## Groundwater Application Review Summary Form

Application # G- 18768

# MEMO

**To:** Kristopher Byrd, Well Construction and Compliance Section Manager  
**From:** Joel Jeffery, Well Construction Program Coordinator  
**Subject:** Review of Water Right Application G-18768  
**Date:** September 6, 2019

Figure 3. Water-Level Trends in Nearby Wells

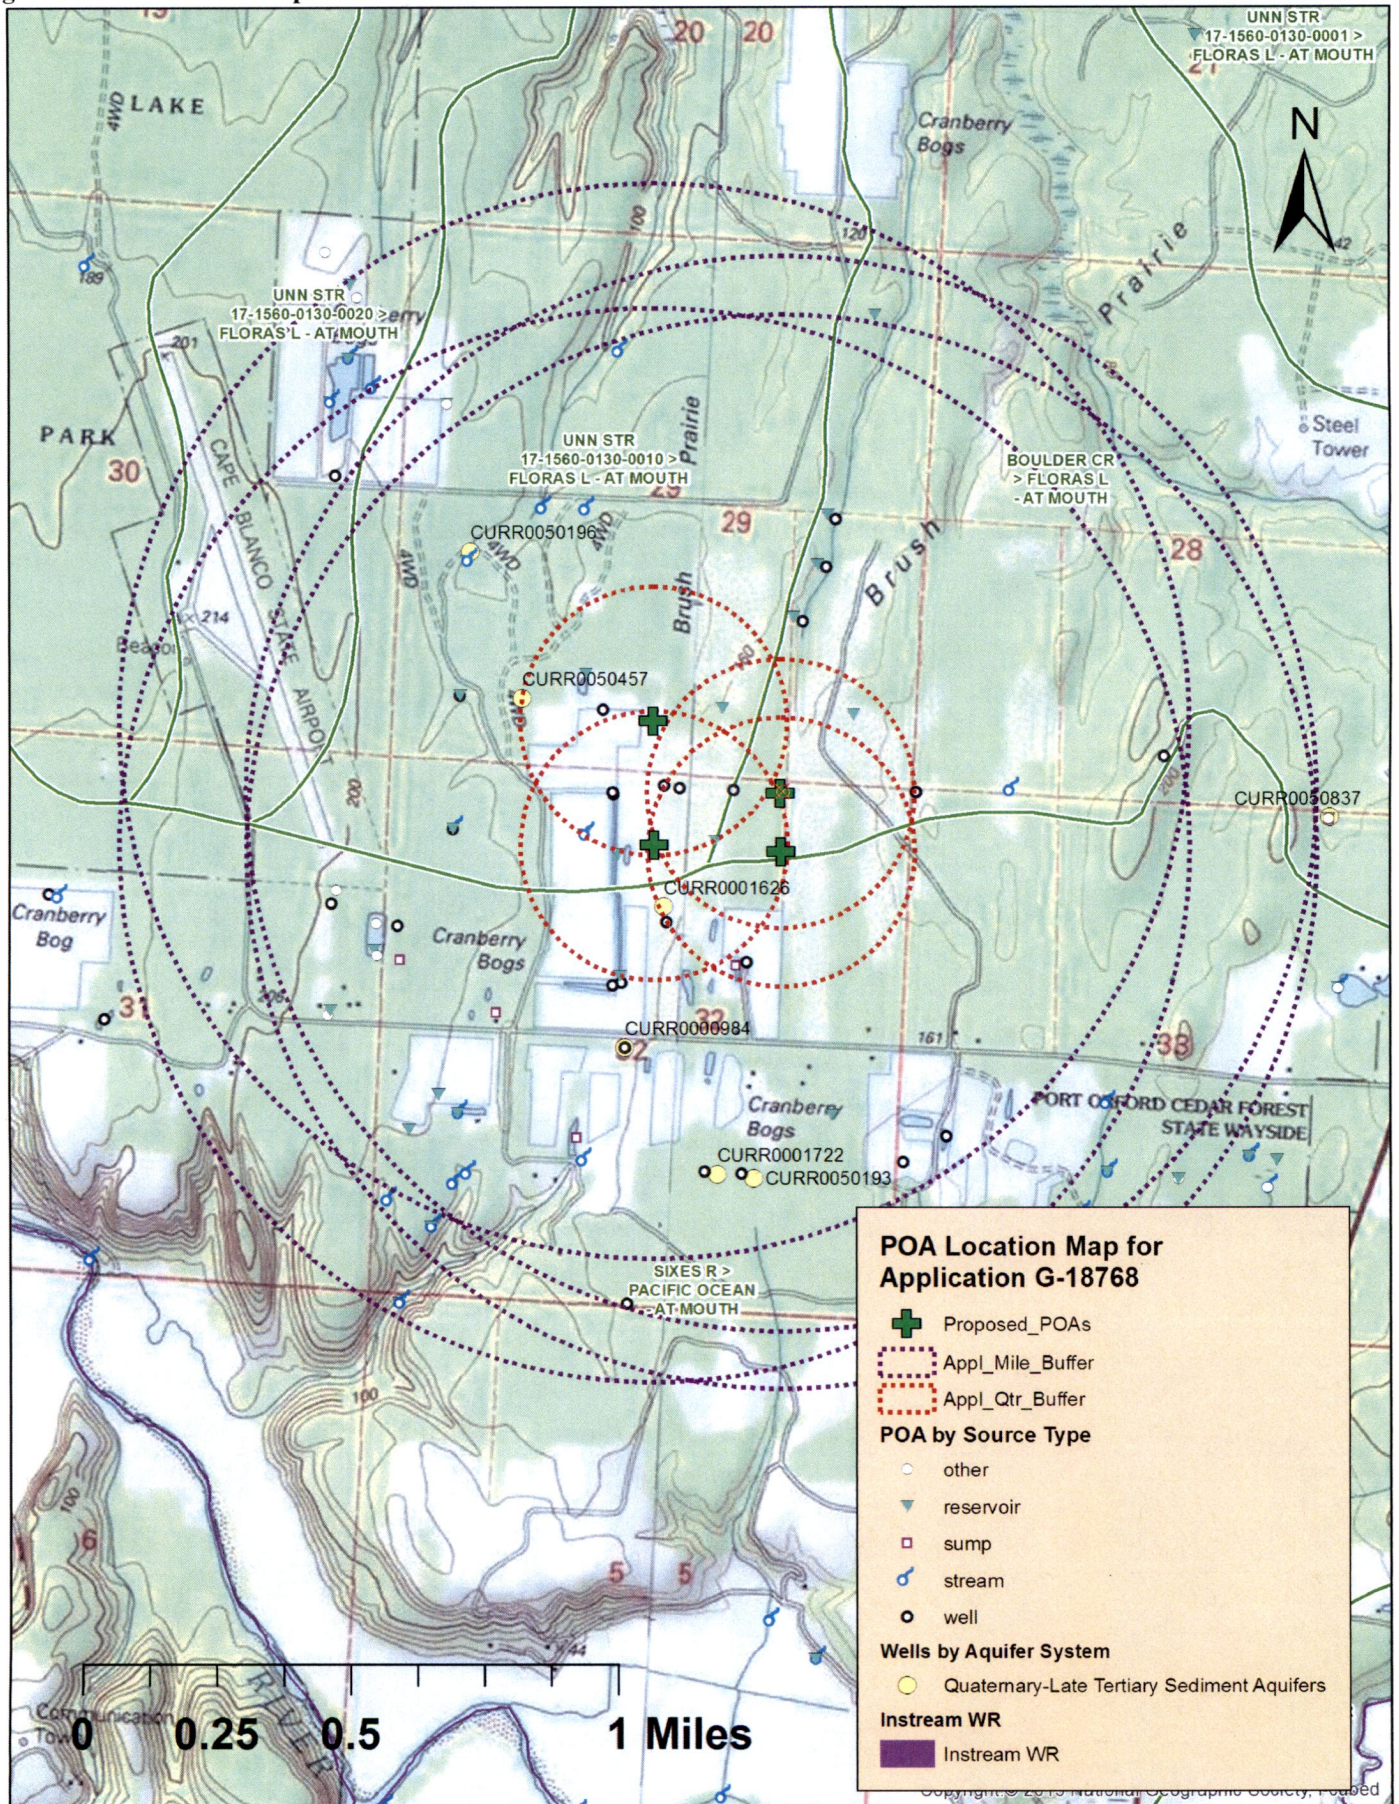
Water levels in wells are typically shallow (typically between 5-20 feet bls) with seasonal fluctuations between 5 and 25 feet. Water level records in adjacent wells show no clear evidence for systemic declines (see Figure 3). There are several valid POAs within 500-1000 feet of the applicant’s wells, but the potential for significant interference is relatively low in this unconfined, moderately transmissive aquifer system. Additionally, Department is not currently aware of interference/injury complaints in this area.

Figure 4. Stream Depletion Model Parameters and Results (Hunt, 1999)

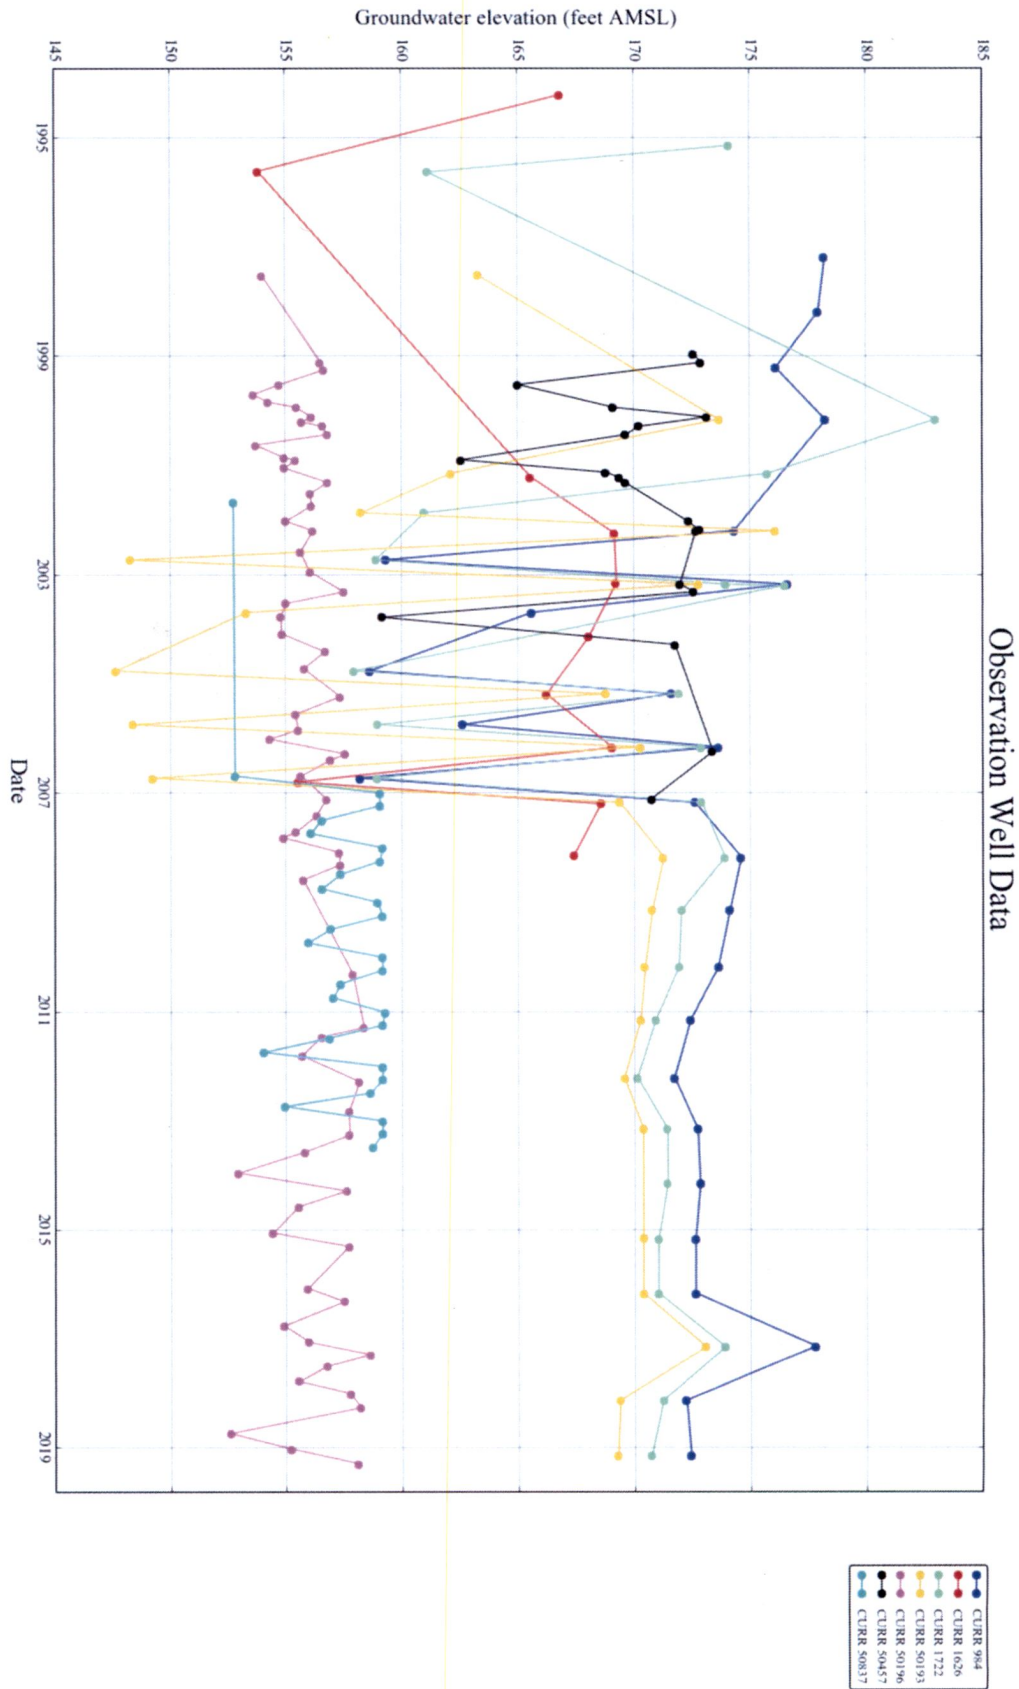
**Comments:** Interference with surface water is estimated using the Hunt (1999) stream depletion model using a parameter range representative of the local geology. Results are presented in Figure 4.
